**CITY OF ST. HELENS PLANNING DEPARTMENT
STAFF REPORT
Variance and Access Variance, V.15.20 & V.16.20**

DATE: November 3, 2020
TO: Planning Commission
FROM: Jennifer Dimsho, AICP, Associate Planner
Jacob A. Graichen, AICP, City Planner
APPLICANT: c2design, c/o Chuck Cohen
OWNER: Equity Trust Company Custodian, c/o Brian Zender
ZONING: Apartment Residential, AR
LOCATION: Vacant lot at the dead end of S. 2nd Street; 4N1W-3CA-500
PROPOSAL: Variance to allow a 0' yard (setback) along a proposed access easement and an Access Variance to allow a 2-foot aerial (2nd story) encroachment into a proposed access easement

Knob Hill Townhouses **Variance Request**
495 & 497 S. Second Street
St. Helens, OR 97051

1 SITE PLAN NOTE: SEE EXTERIOR ELEVATIONS FOR ADDITIONAL INFO

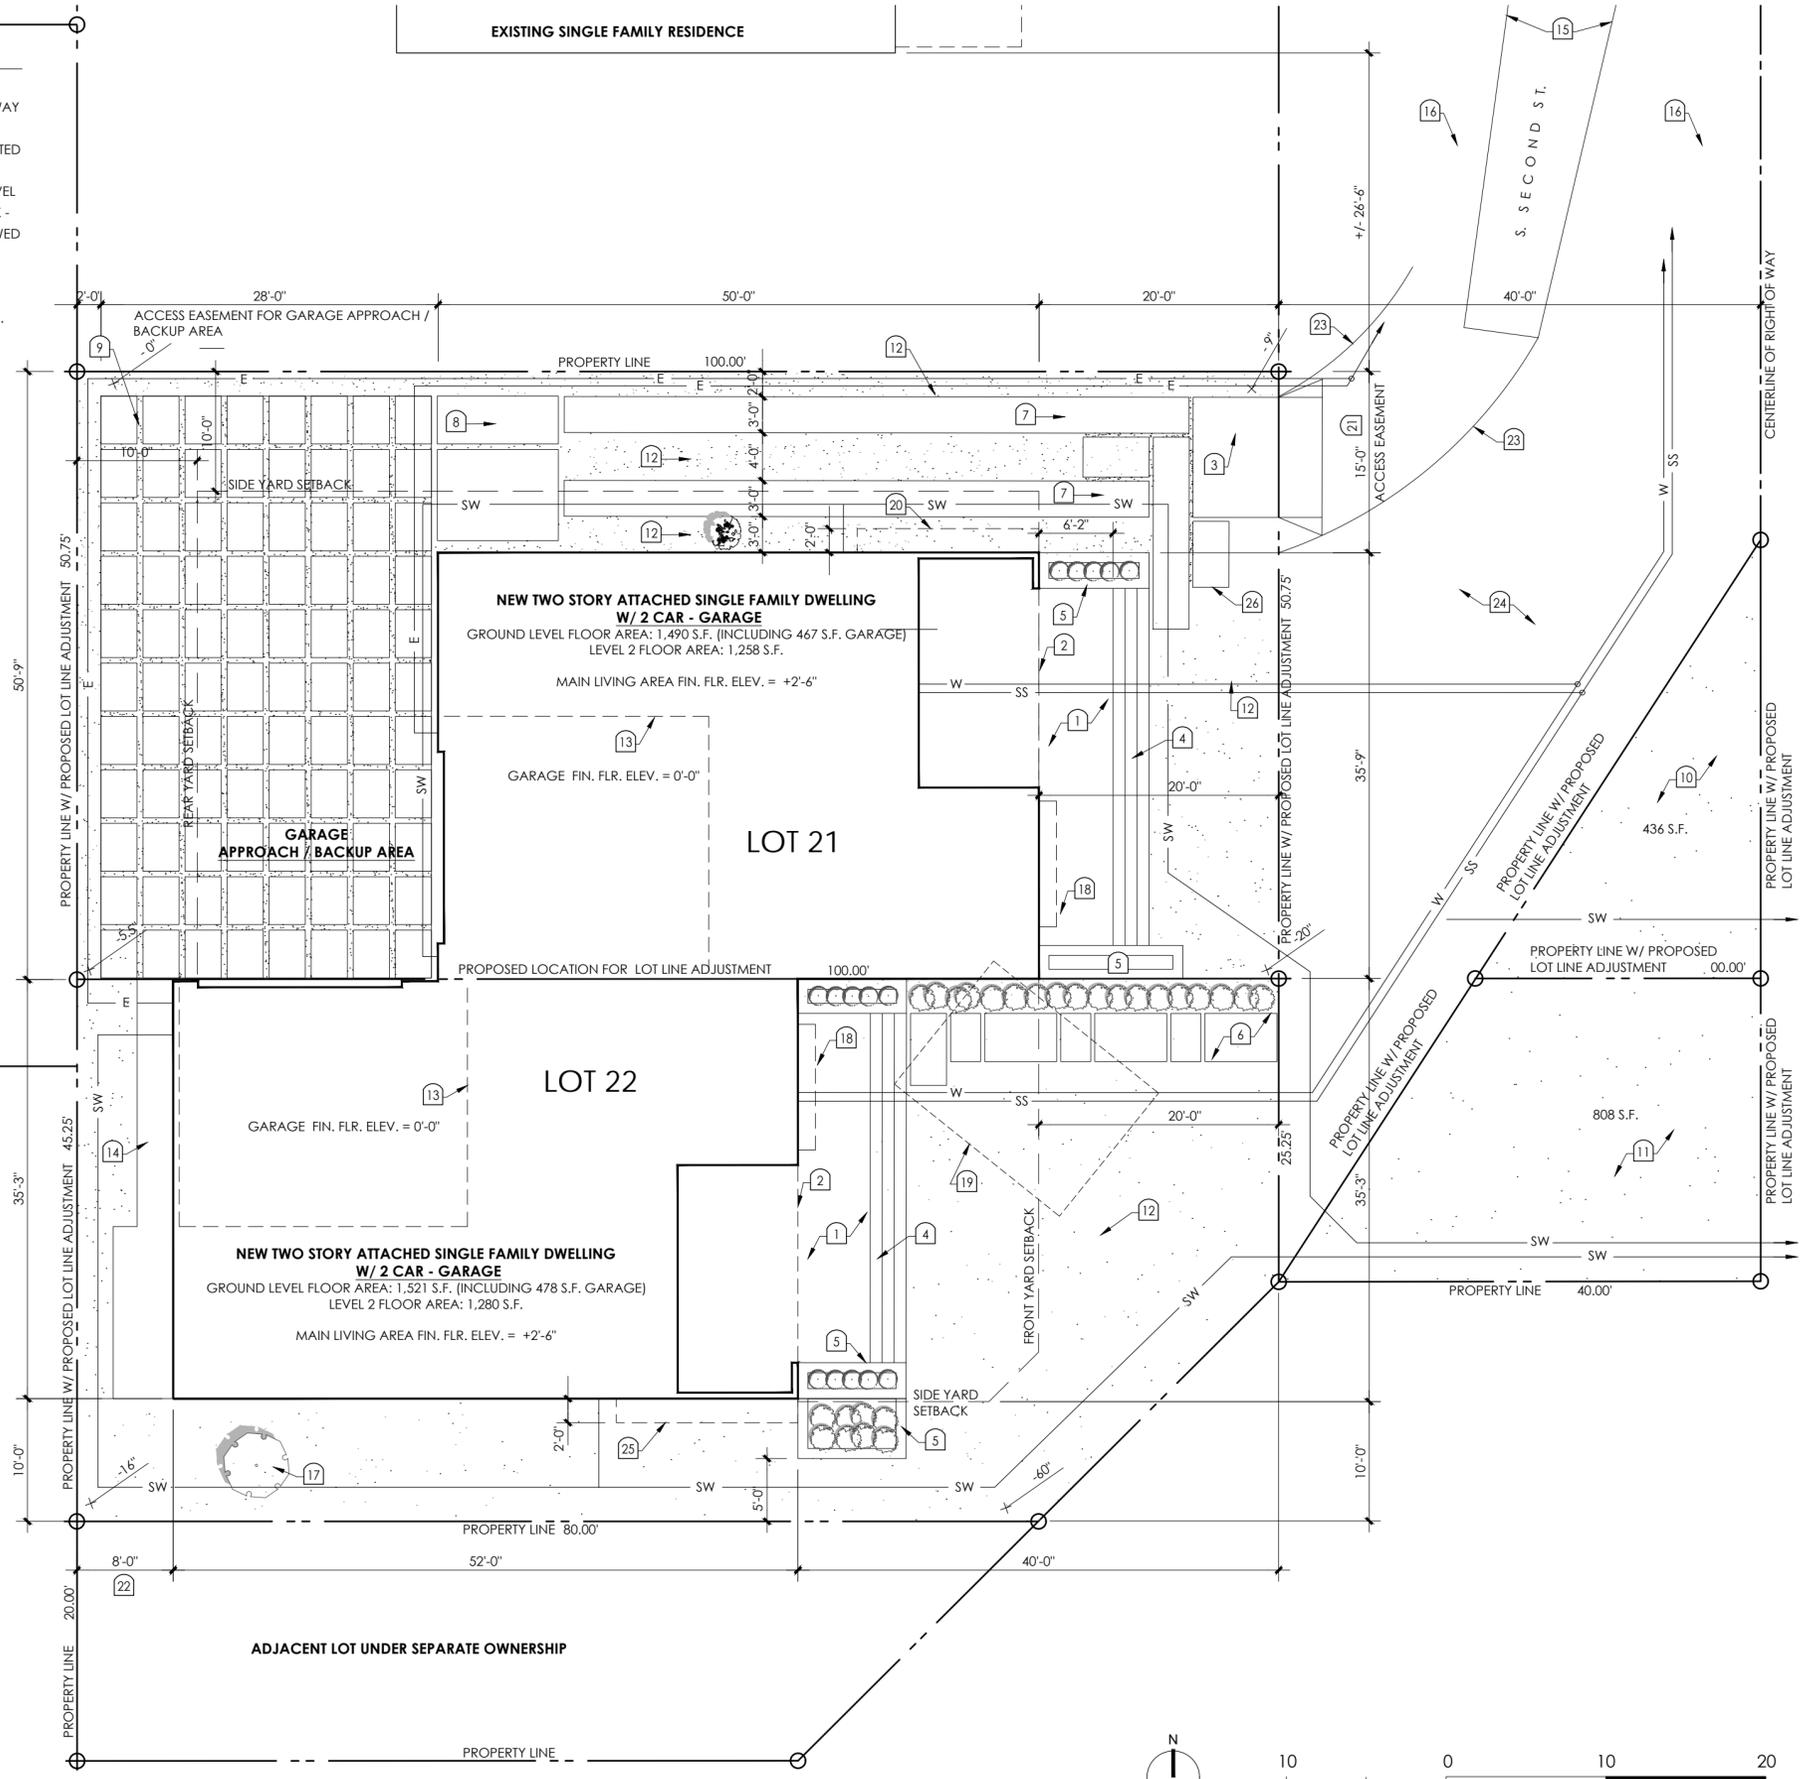
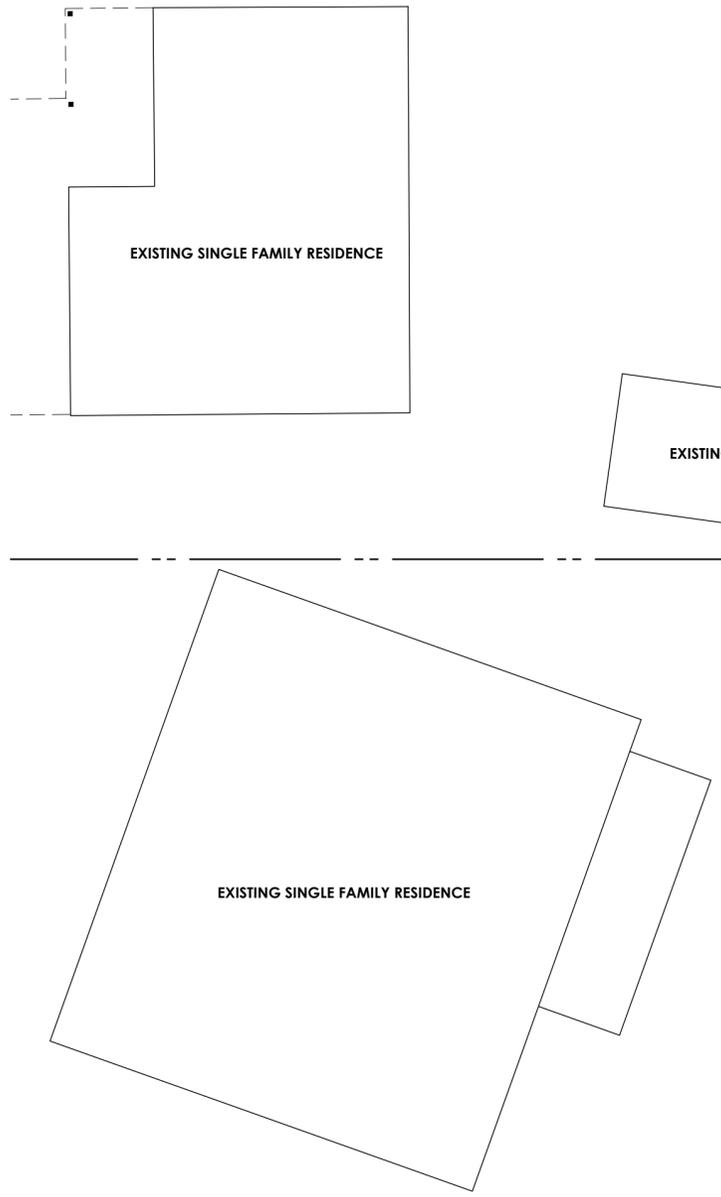
- It appears landscaping (grass) is proposed along the rear property line with the proposed administrative setback exception and along the yards abutting the access easement.
Should additional landscaping, buffering, or screening be provided to reduce impacts to abutting properties affected by the setback reductions?

- **Does the Planning Commission find that the setback variance along the access easement will not be detrimental to other properties in the same zoning district and vicinity? Does the variance still allow adequate air, light, and space between properties?**

- Staff comments: Regarding traffic and parking, the reason the applicant is proposing a shared access easement is to allow for an orderly and efficient development of the lots. Off-street parking requirements will be met, and the applicant is proposing a 28' wide easement in the back of Lot 21 to ensure room for vehicular maneuvering.

- Regarding landscaping and stormwater runoff, the applicant is proposing concrete slabs with 6" grass joints between slabs for the 28' wide driveway in the back of Lot 21, and concrete driveway "strips" for the wheels, as opposed to paving the full 10' width. This will help reduce the stormwater runoff from the driveway and allows for increased water retention during rain. Since this type of driveway design is not a requirement, **as a condition of approval for the variance, the Commission could require a permeable or semi-permeable driveway which could help limit stormwater impacts to surrounding properties and reduce the potential stormwater runoff impacts of the variance.**

- Note that the code requires asphalt or concrete surfaces, or other similar type of materials approved by the City. Whether or not 6" grass joints will meet this requirement will be up to City staff.

1 NORTH ELEVATION

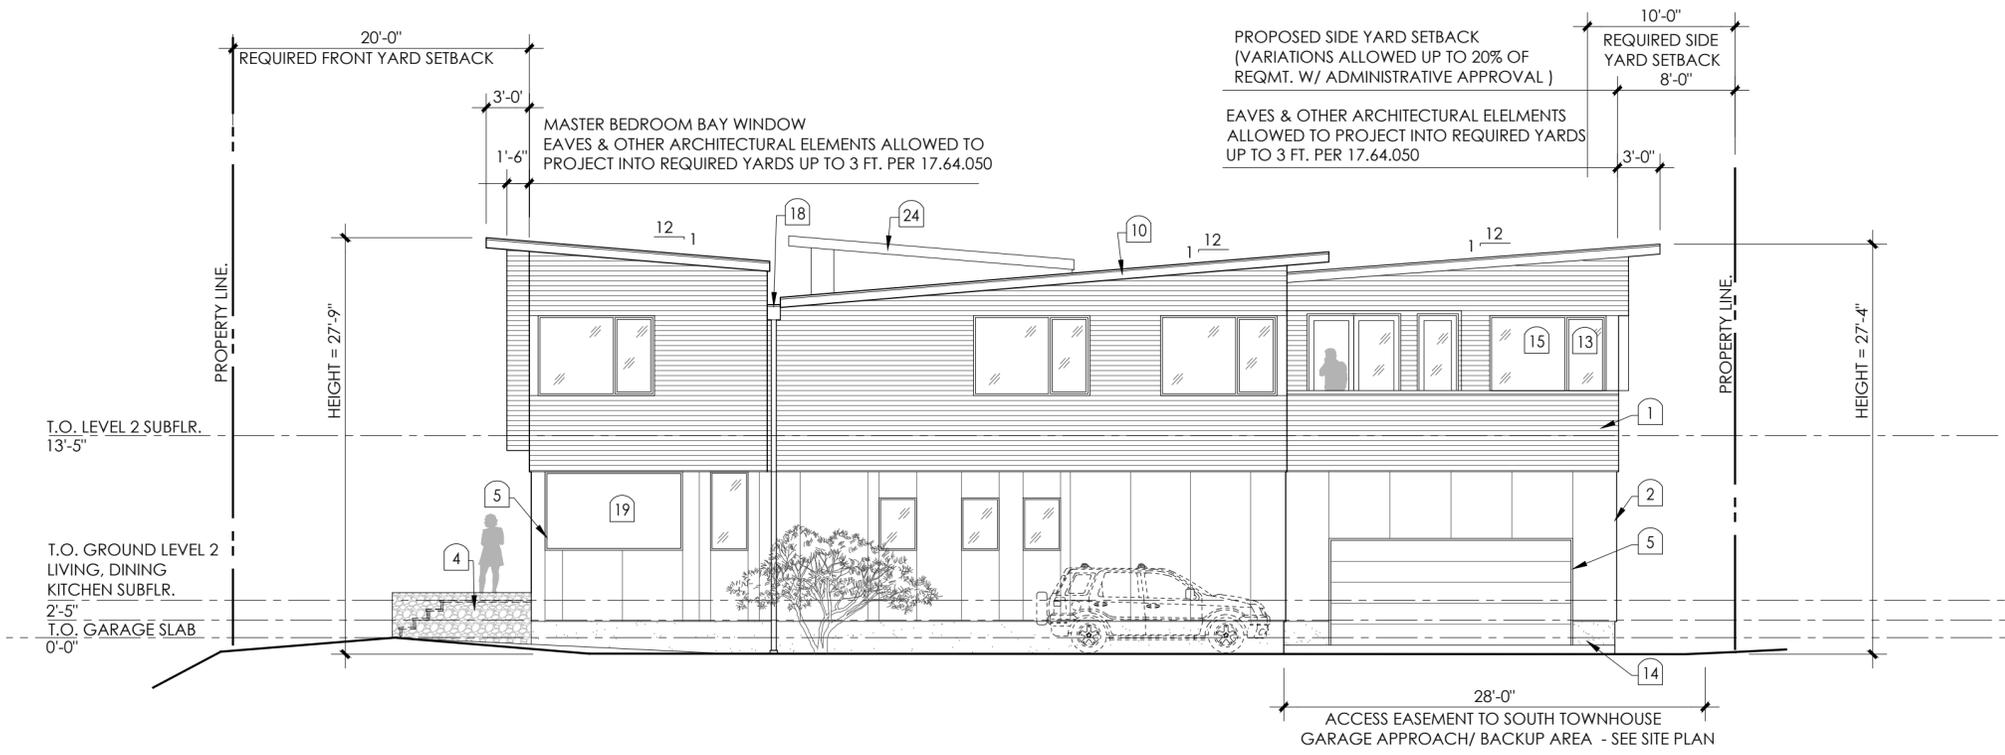
- See applicant's narrative.
- Staff comment: The applicant is proposing to utilize a cantilevered building solution that will increase the livable space of the detached single-family dwelling, while limiting impacts to the access easement. The vehicular clearance under the cantilevered structure is over 11'.

A cantilevered portion of the project's second floor level is proposed to encroach 2 feet vertically for a length of 16 feet and 11 feet above a 15-foot-wide vehicular access easement (see attached site plan and elevation drawings).

The configuration of the encroachment into the easement has been carefully configured to not conflict with the actual driveway's paved area and is sufficiently above the access easement (eleven feet) to avoid any impact on vehicular ingress and egress from the site.
